Arizona Mining Reform Coalition – Access Fund –
Concerned Citizens & Retired Miners Coalition –Earthworks – Sierra Club

May 31, 2022

***Re: Comments and Objections to ADEQ's Renewal of the Resolution Copper Mining
AZPDES Permit No. AZ0020389 (LTF No. 90471)***

Figure 5: Modeling Basins that have Water Quality Data

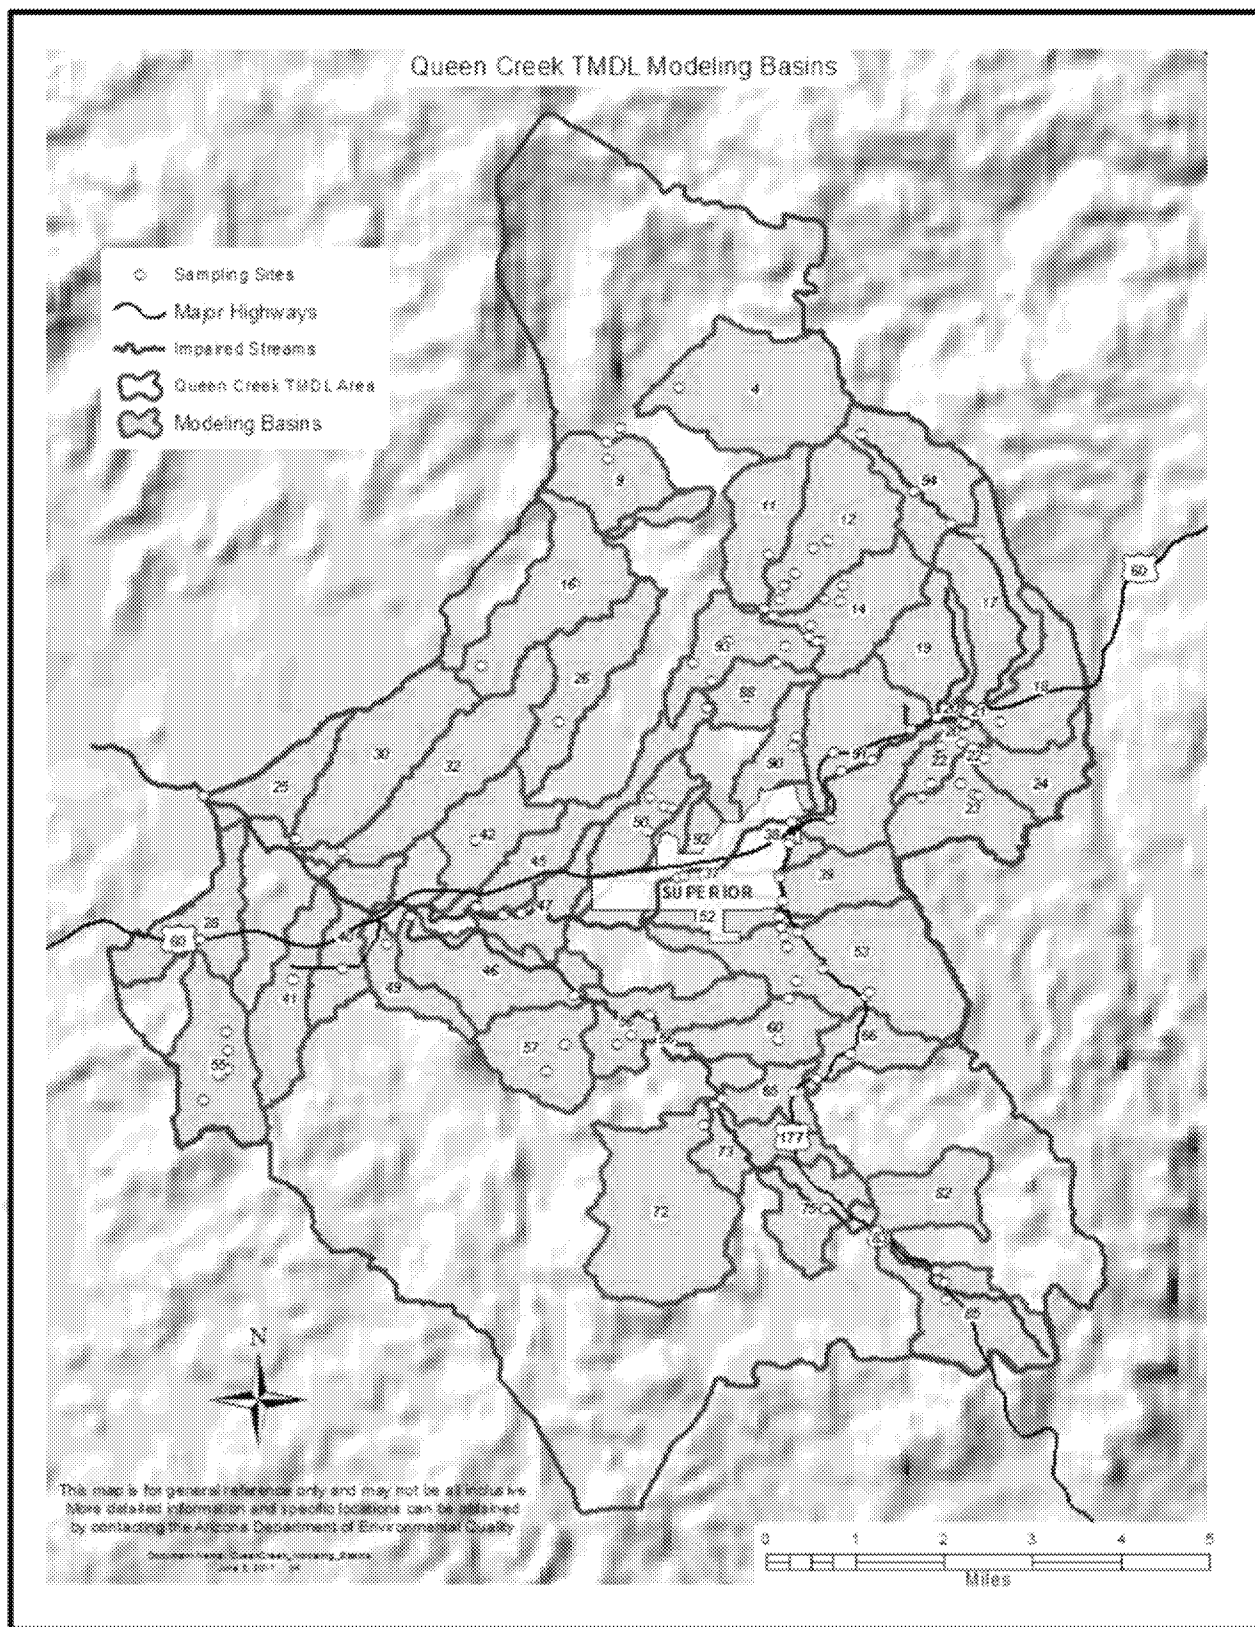
Figure 5 of the draft shows that ADEQ did not include a number of the sub-basins in their modeling. Since some of the sub-basins not used in the modeling are quite large, the modeling exercise itself is fatally flawed. Why are some sub-basins not used? What rationale was used to choose the basins used? How were the “representative” basins chosen to assure that they are truly representative?

Figure 6: Observed vs Simulated Flows in Modeling Basin 46- Arnett Creek

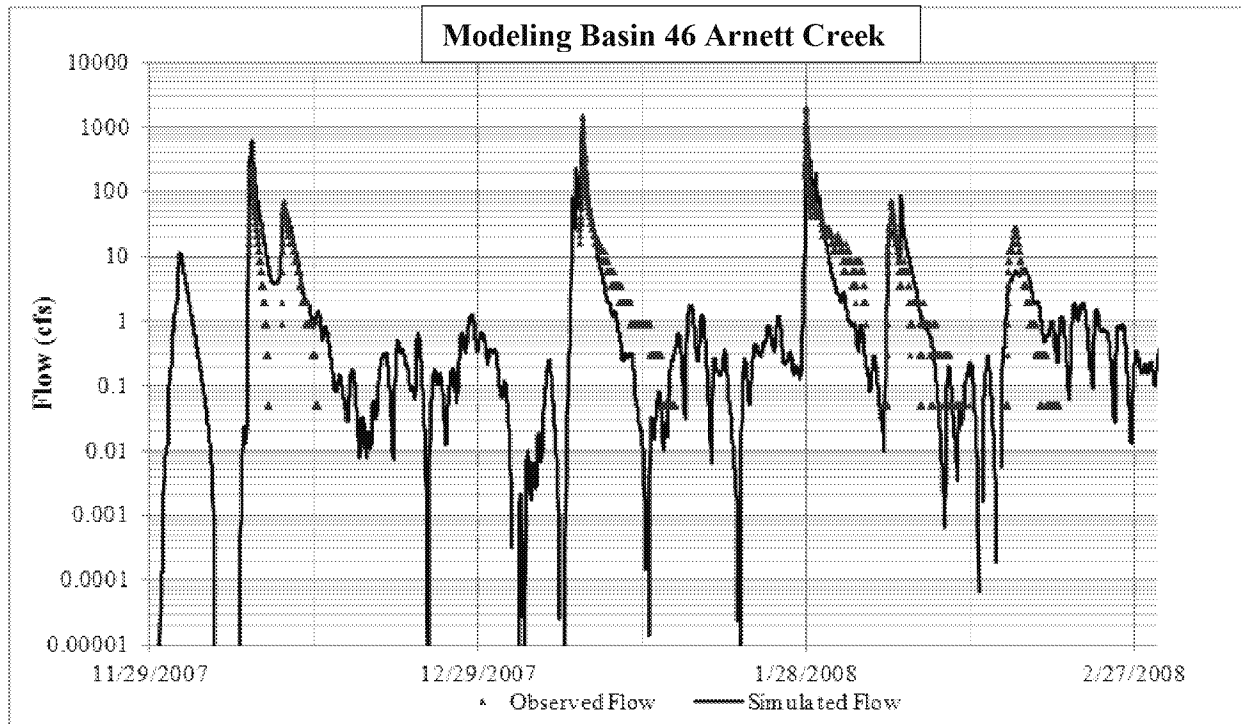
Figure 6 does not support the draft reports conclusion that actual data matches simulated modeling. Was this a cherry-picked graph or do other sub-basins also show any kind of correlation? To us, Figure 6 does not show an acceptable visual agreement between observed and simulated flows.

Figure 7: Observed vs Simulated Dissolved Copper in Modeling Basin 46 - Arnett Creek

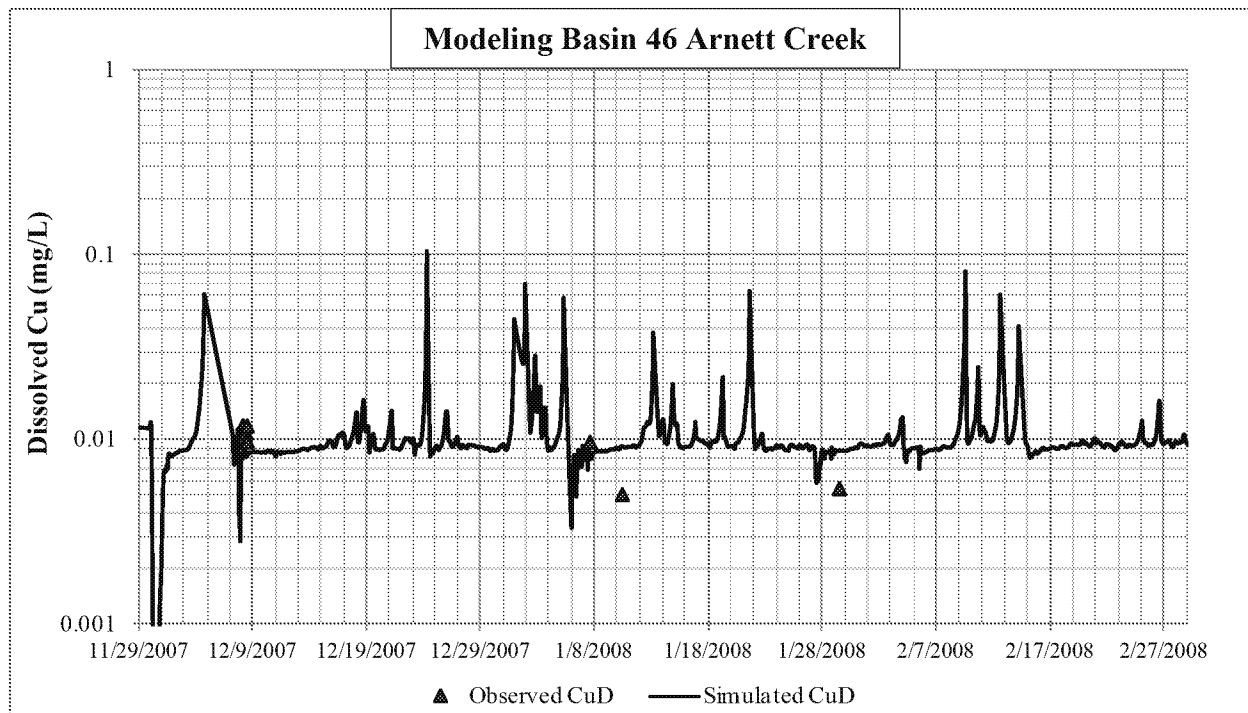
As with Figure 6, there is simply not enough data in Figure 7 to support ADEQ’s conclusions.
